<b>DOCKETED</b>	
<b>Docket Number:</b>	23-AFC-01
<b>Project Title:</b>	Morton Bay Geothermal Project (MBGP)
<b>TN #:</b>	254691
<b>Document Title:</b>	Hudson Ranch Power 1 Comments - Morton Bay Geothermal Project Impact Screening Study
<b>Description:</b>	N/A
<b>Filer:</b>	System
<b>Organization:</b>	Hudson Ranch Power 1
<b>Submitter Role:</b>	Public
<b>Submission Date:</b>	2/26/2024 1:26:52 PM
<b>Docketed Date:</b>	2/26/2024

*Comment Received From: Hudson Ranch Power 1  
Submitted On: 2/26/2024  
Docket Number: 23-AFC-01*

## **Morton Bay Geothermal Project Impact Screening Study**

## **Morton Bay Geothermal Project Impact Screening Study**

Figure 1: One square mile encompassing Morton Bay (proposed) and HPRI (existing) production well fields totaling approximately 217 MW.

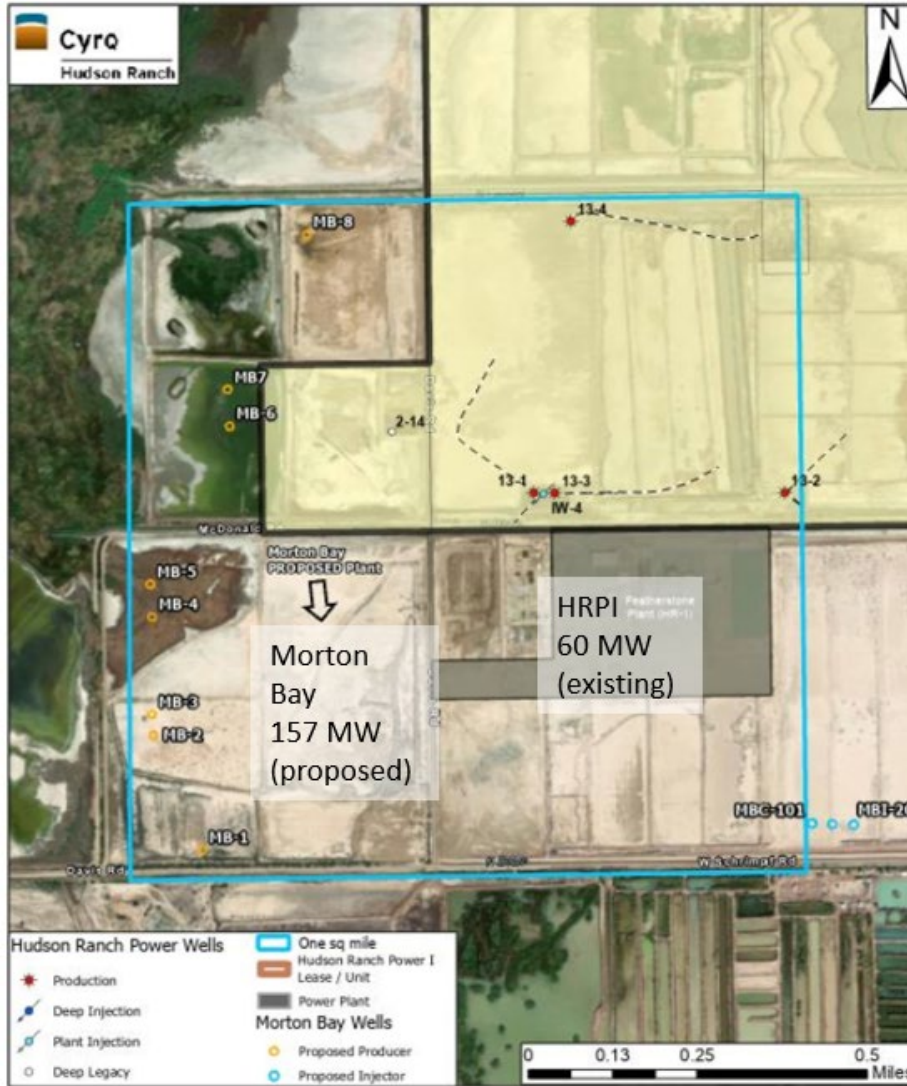
While GRG understands this guideline is approximate and not absolute, Morton Bay as proposed reaches 85 MW/km<sup>2</sup> (217 MW/mile<sup>2</sup>) in that area of the reservoir (see Figure 1). This is nearly three times the known sustainable power density of the overall SSGF. Further, as shown in Figure 2, the highest reported power densities in the world are less than 45 MW/km<sup>2</sup> (116 MW/mile<sup>2</sup>). In GRG’s opinion Morton Bay’s proposed power density of 85 MW/km<sup>2</sup> (217 MW/mile<sup>2</sup>) will cause accelerated decline for both Morton Bay and HRP I. GRG recommends a lower power density of development for the benefit and long-term sustainability of both Morton Bay and HRP I.

Figure 2: From Wilmarth(2015) showing Salton Sea power density of 30 MW/km<sup>2</sup> (78 MW/mile<sup>2</sup>)

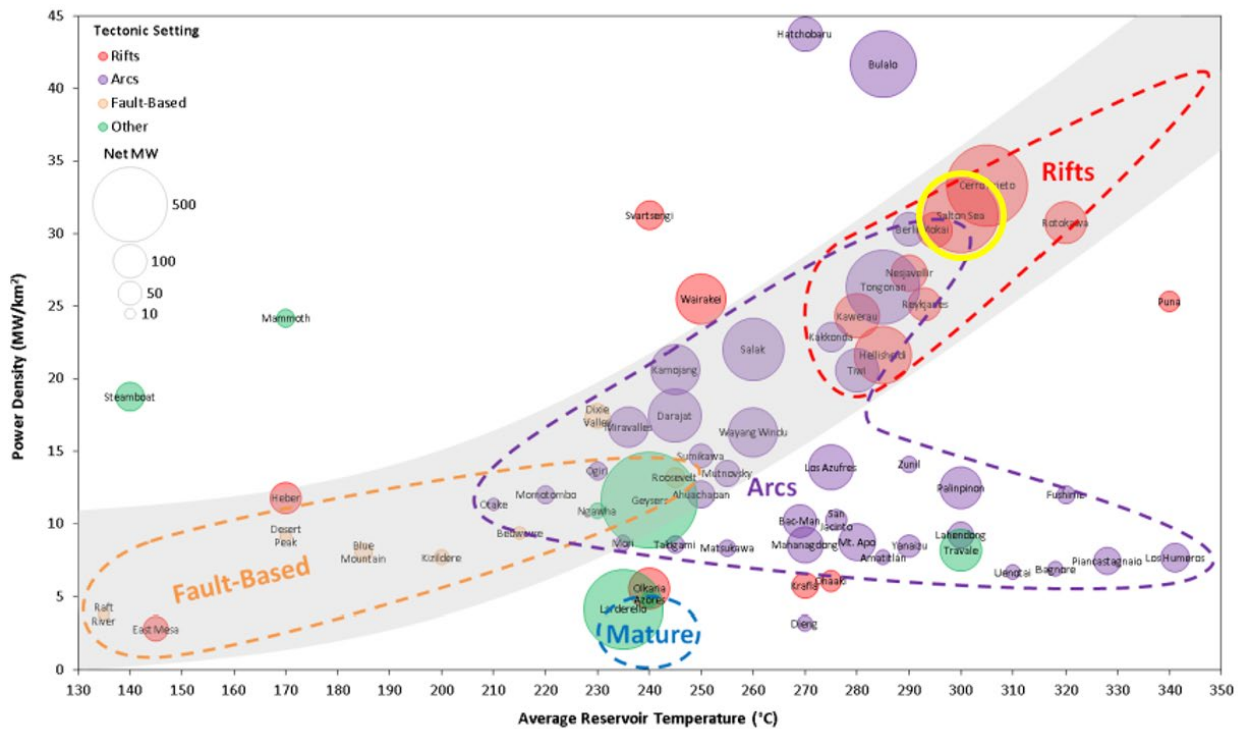
Because a fieldwide reservoir simulation of the SSGF is not available, GRG relied on the power density approach. Both Grant (2000) and Wilmarth (2015) show that a power density of 30 MW/km<sup>2</sup> (78 MW/mile<sup>2</sup>) is a reasonable expectation for the SSGF when compared to other fields with similar reservoir temperatures, 300 to 320 °C (570 to 610 °F) as shown in Figure 2.

**Figure 1. Hudson Ranch Power I Wellfield and Morton Bay Project Wellfield.**

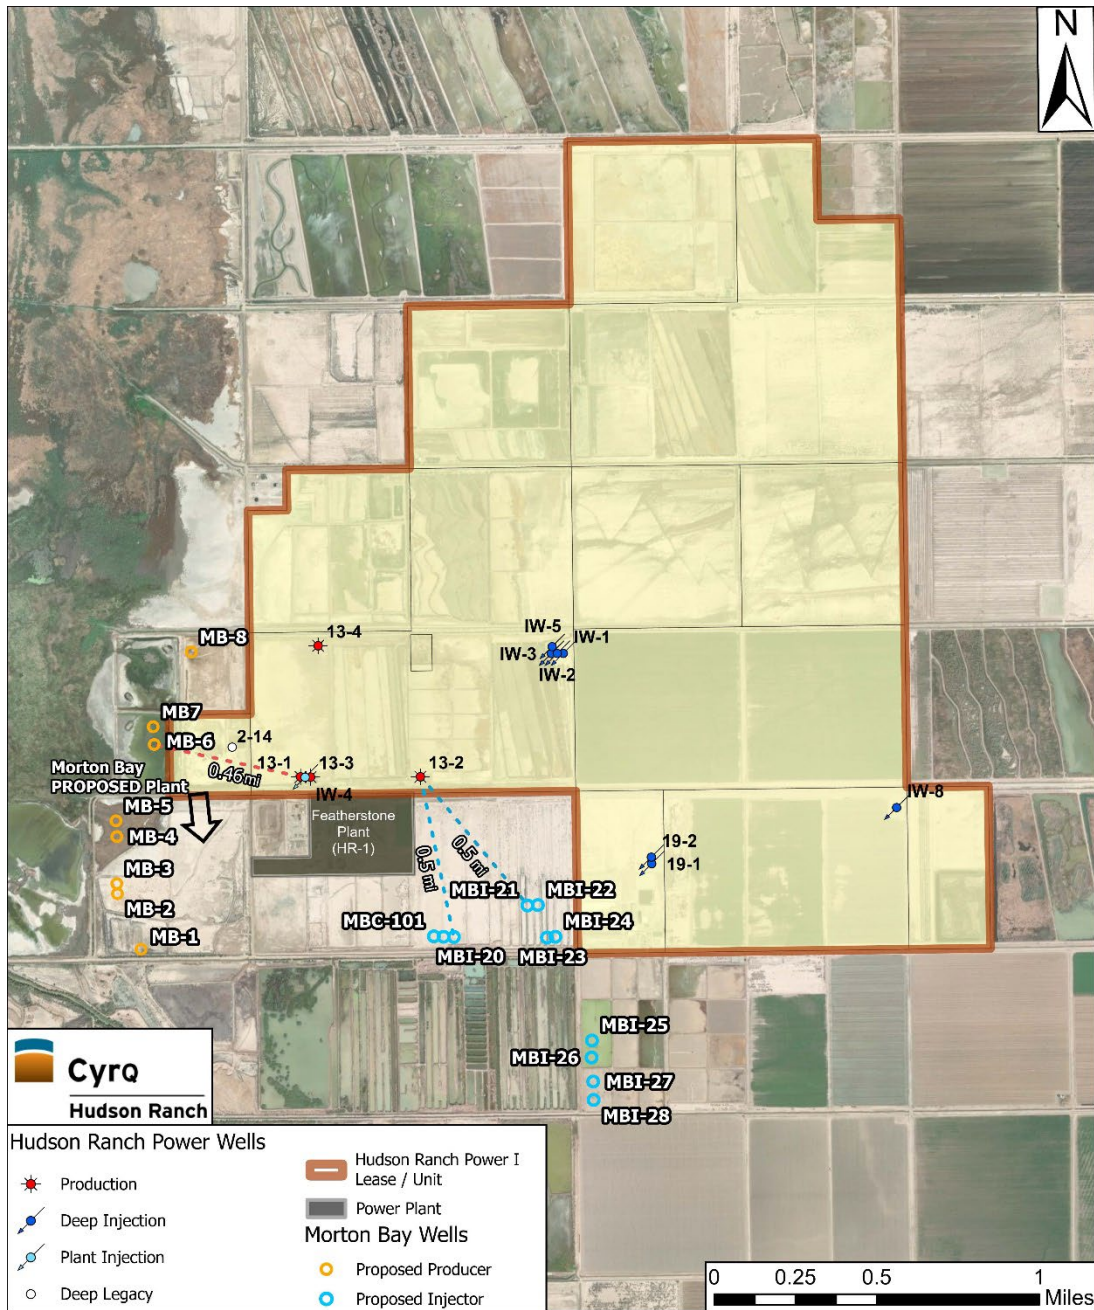
The Morton Bay Geothermal Project (Morton Bay) proposes to install 157 MW of generation capacity from 8 production wells within approximately ½ mile of the existing Hudson Ranch Power I (HRPI) Geothermal Project. This screening study evaluates the Morton Bay proposal against numerical simulation, empirical data sets, and global analogues to assess the impact of the project on the Salton Sea Geothermal Field's (SSGF) sustainable producibility. Through all lenses of evaluation, the proposed project is expected to exceed the sustainable capacity of the SSGF. Proceeding with this project as designed is likely to result in rapid and material degradation of the SSGF resource, which will negatively impact renewable power generation.

The Morton Bay Geothermal Project (Morton Bay) proposes a continuous rating of approximately 157 megawatts (MW) gross from the Salton Sea Geothermal Field (SSGF).<sup>1</sup> The project plans to drill and complete eight production wells and eleven injection wells in order to achieve this targeted amount of power generation. Three of the proposed producers sit less than 2,200 ft west from the current HRPI Unit boundary, while five of the proposed injectors sit less than 2,500 ft south from the current HRPI production wells (Figure 1). The proposed density and high flow rates of these wells raise significant concerns for the long-term management of the SSGF.

**Figure 2. Simulation Case 5 with injection immediately south of the three Hudson Ranch producers (taken from GeothermEx, 2010)**

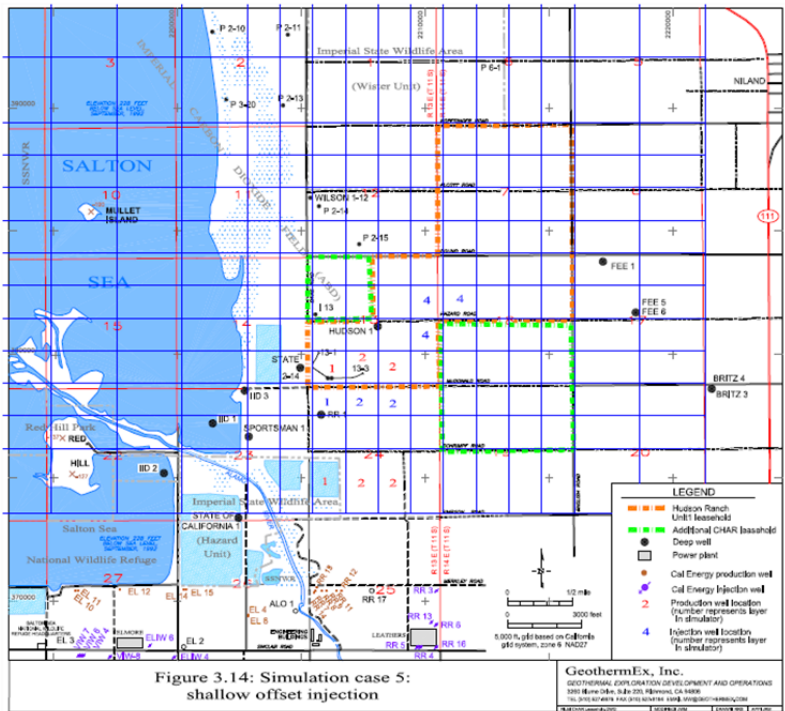
**Case 5:** "... assumes injection immediately south of the three Hudson Ranch producers and at the same level in the reservoir. Case 5 also includes three additional production locations still further south (again at corresponding levels in the reservoir), on the premise that a competing plant would require production as well as injection."<sup>6</sup> Refer to Figure 2 where the offsetting wells are located at ¼ mile (or 1,320 ft) away from the HRPI producers. Each injector assumes a mass flow rate of 1,046 kph.

Case 5 exhibited an immediate and material impact on the HRPI wellfield, resulting in a forecasted enthalpy decrease of more than 50 British thermal units (BTU)/lb in less than 10 years. Case 6 showed a smaller impact, with enthalpy decreasing by approximately 13 BTU/lb over the same period (Figure 4). There are at least two caveats that imply these cases grossly underestimate the impact a project like Morton Bay will have on the SSGF and HRPI production:

**Figure 3. Simulation Case 6 with injection wells ¼ mile further south (taken from GeothermEx, 2010)**

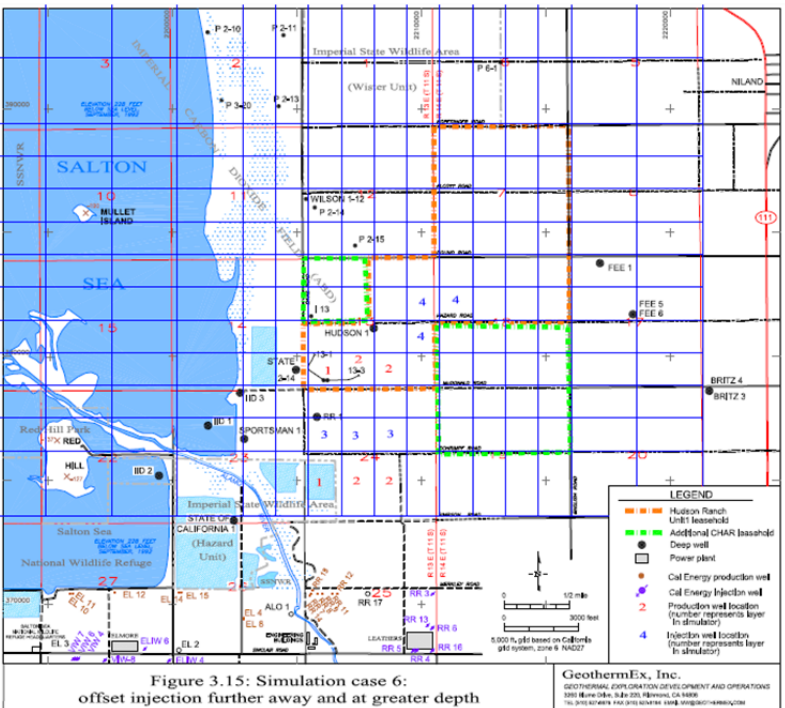
**Case 6:** "is a modification of Case 5, such that the offsetting injection wells are moved one grid block (i.e., ¼ mile) further south and are assumed to inject at greater depth (into Level 3), while the production further south is assumed to remain the same."<sup>6</sup> Refer to Figure 3 where the offsetting wells are located at ½ mile (or 2,640 ft) away from the HRPI producers. Each injector assumes a mass flow rate of 1,046 kph.

**Figure 4. Comparison of Cases 5-8 for production well 13-2 (taken from GeothermEx, 2010)**

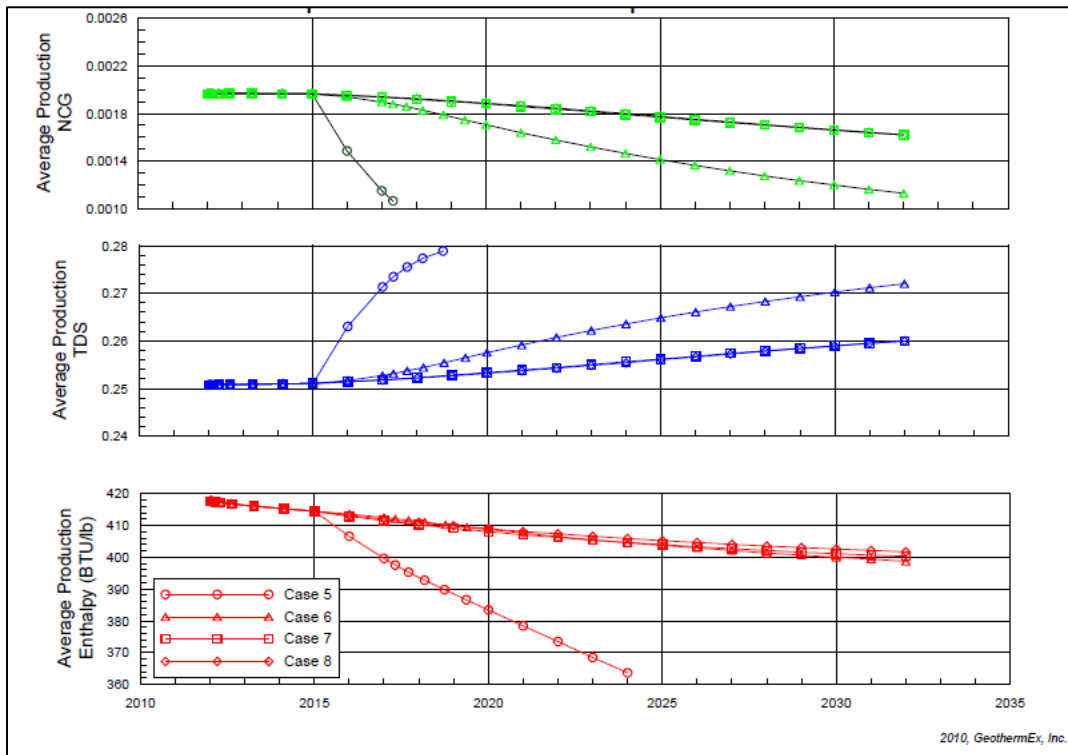
- The simulation assumed total injection rates near 3,150 kph. A new Morton Bay plant targeting 157 MW gross would need approximately 11,200 kph of production, and similar quantities of injection assuming similar brine enthalpies and plant efficiencies to HRPI. This is 3.5 times greater than envisioned in the simulation and is expected to significantly increase the negative impact on fluid enthalpy compared to this reference model.
- The simulation assumed a homogeneous, single-porosity reservoir layer with 500 millidarcy permeability. In reality, the SSGF hosts both stratigraphic and fracture permeability that could be significantly greater than this assumption, further multiplying the negative impact of offset wells on each other.

**Figure 5. Pressure Zinterference from the Morton Bay production (11,200 kph of total production)**

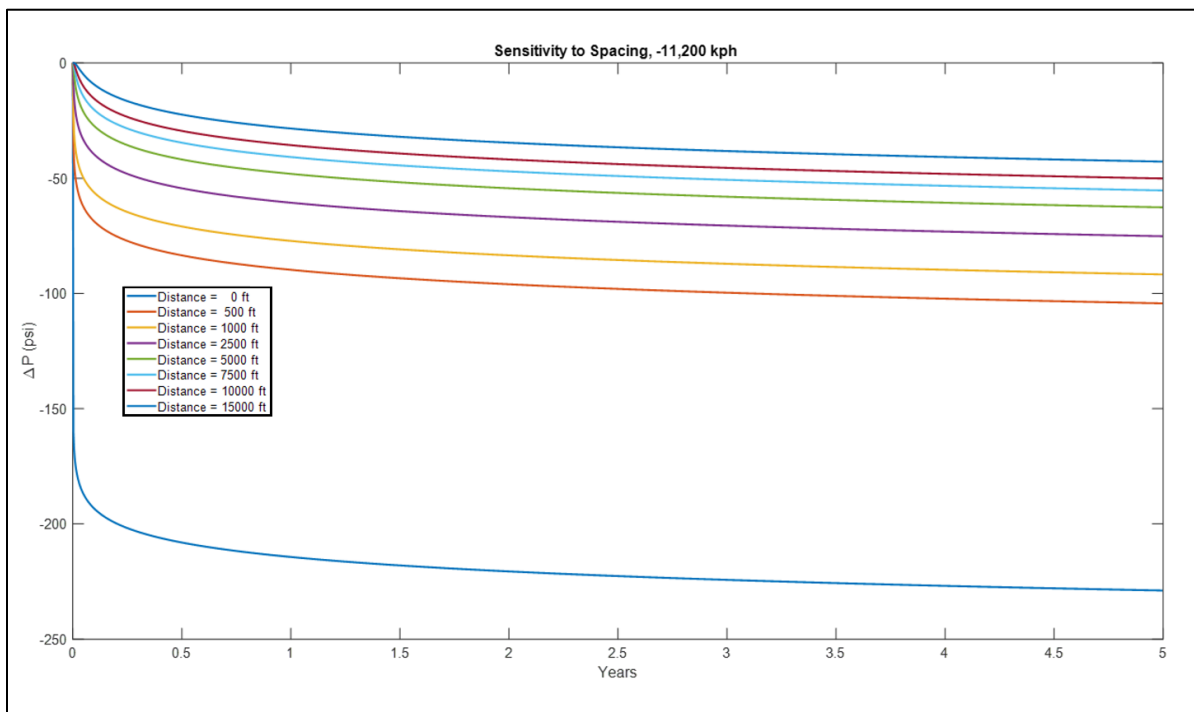
The initial analytical model (Figure 5) studied the production impact on the HRPI wellfield given different spacing setbacks for the Morton Bay producers at the flow rates needed to achieve 157 MW gross generation: roughly 11,200 kph total. Spacing setbacks between 500 ft and 15,000 ft were tested, yielding pressure drawdown in the reservoir between 102 and 35 PSI after 5 years of production. At 2,500 ft of separation (roughly the distance proposed between HRPI and Morton Bay of ~½ mile), and assuming a constant operating wellhead pressure of 400 PSI, the anticipated reservoir pressure drawdown approaches 75 PSI, resulting in a 350 KPH reduction of production on each HRPI producer, i.e., 1,400 kph of total mass reduction, equal to a loss of roughly 18.5 MW net in winter conditions (Figure 5). Even if the setback distances were expanded to 15,000 ft (nearly 3 miles away), a reservoir drawdown of 35 PSI is expected, which translates into a reduction in HRP1’s generation of 600 kph or 8 MW net in winter conditions.

**Figure 6. Pressure interference<sup>3</sup> from the Morton Bay production (3,500 kph of total production)**

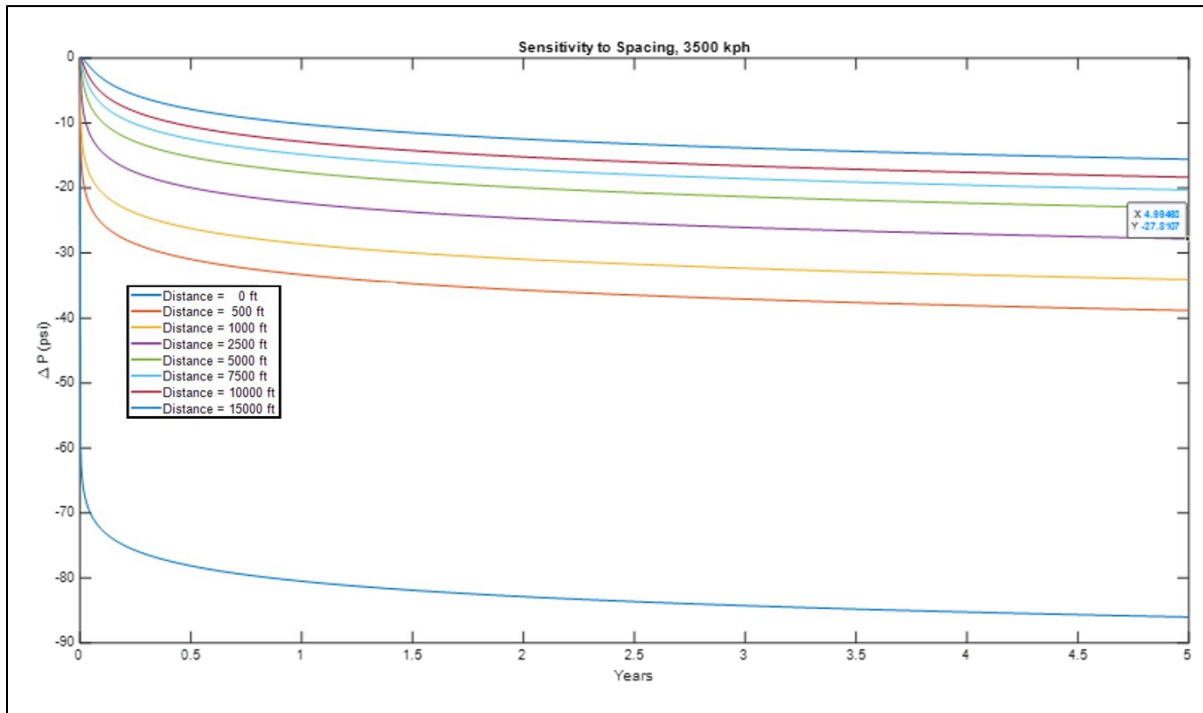
An alternative Pressure Transient Analysis was proposed, reducing the total mass produced to 3,500 kph, or a roughly 50 MW project. All other parameters remained constant. At this lower generation target, with consistent spacing setbacks ranging from 500 ft to 15,000 ft, the estimated pressure drawdown in the reservoir varied between 39 and 16 PSI after 5 years of production. At a separation of 2,500 ft, and assuming a constant operating wellhead pressure of 400 PSI, the expected reservoir pressure drawdown approaches 27 PSI, resulting in a reduction of 105 KPH in production for each HRPI producer, totaling a reduction of 420 kph in total mass, equivalent to a net loss of 5.5 MW in winter conditions even if a proposed project is scaled back to 50 MW (Figure 6).

**Figure 7. 2018 Tracer test injecting on IW-4 and reading on the HP Separator**

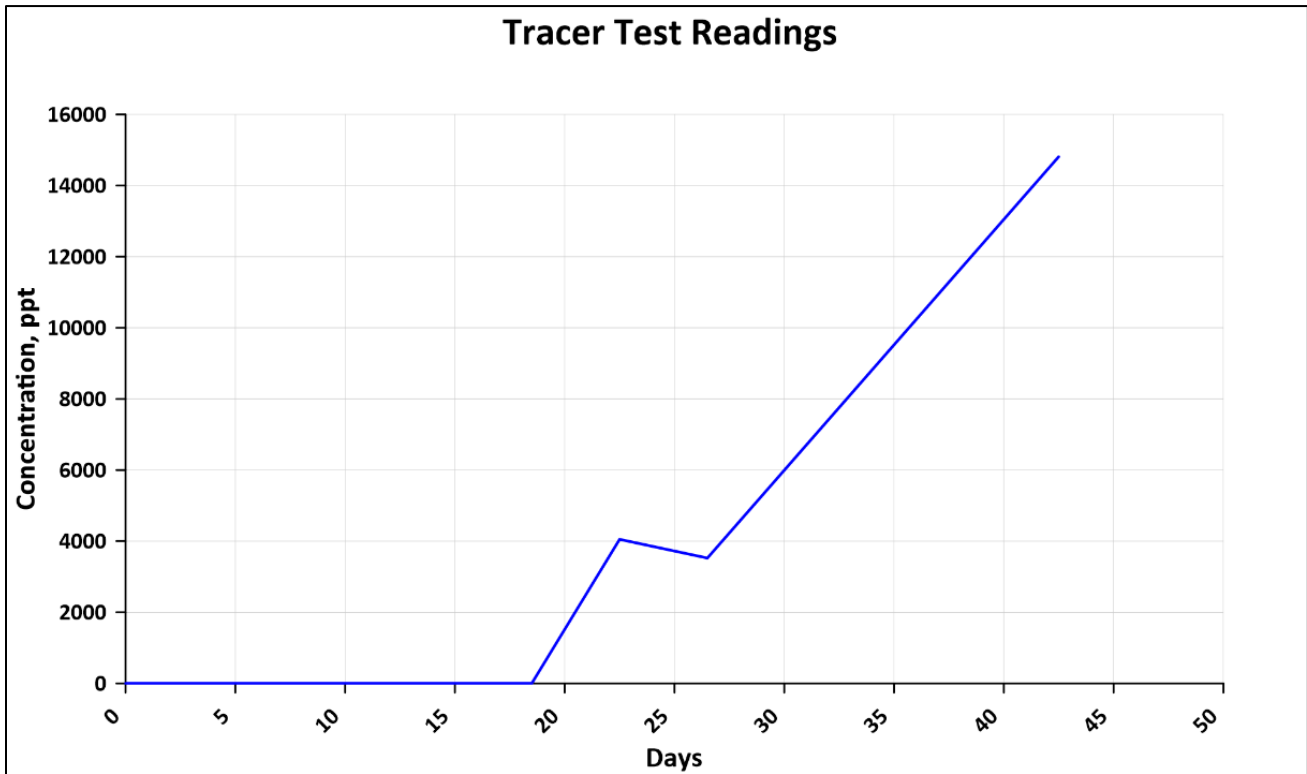
In 2018, a tracer test analysis was conducted on the sole shallow injection well (IW-4) for the HRPI project at the time. This test utilized ethylenediaminetetraacetic acid (EDTA) added to the IW-4 injectate which was injecting at a relatively low flow rate of ~390 KPH. Subsequently the produced brine was sampled in the high-pressure separator, where all produced fluid enters the HRPI power plant. During the test, the tracer was initially detected in HRPI’s production wells 23 days after injection, reaching its peak after 43 days (Figure 7). Well IW-4 is completed at -2,967 ft ASL, meanwhile, all production wells at HRPI are completed at -7,122 ASL or deeper. The test demonstrates the important result that shallow and deep reservoirs in the Salton Sea geothermal area are in hydrologic communication.

**Figure 8. 13-2 and 13-3 deep zonal contribution with time**

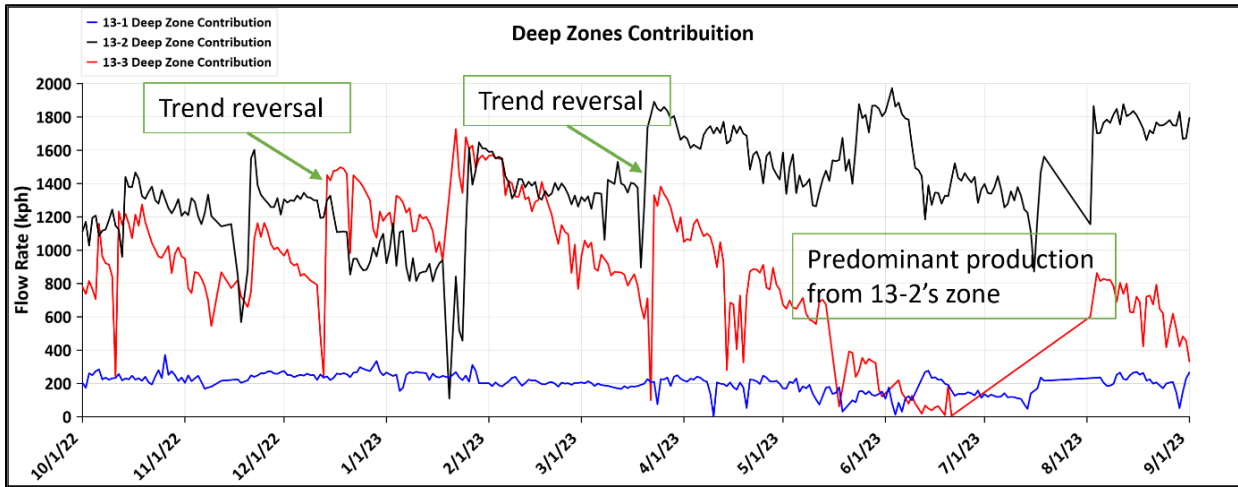
The production contribution of each of HRPI’s wells is monitored via pressure, temperature, flow rate, and salinity. Salinity is also a proxy for the relative contribution of the deep SSGF resource, around 7,000 ft below surface, compared to shallower, less saline and lower enthalpy fluids. HRPI has developed a model to estimate the zonal contribution<sup>5</sup> from each of the production wells. The analysis uses a multi-component mixing model where the contribution from each zone can be estimated using the salinities observed at surface. The model suggests that the deeper zones on HRPI’s production wells 13-2 and 13-3 are in communication, as demonstrated in Figure 8: When well 13-2 is producing higher flowrates, the correlative zone in well 13-3 produces at lower rates and vice versa. For this specific case, the linear distance between the points where the zone intersects the wells is 1,084 ft. The analysis demonstrates that the tight spacing

of the Morton Bay wells to each other may not sustainably produce the flow needed, and also supports the concern that drawdown effects from the large amount of flow will reduce the productivity of the HRPI wells.
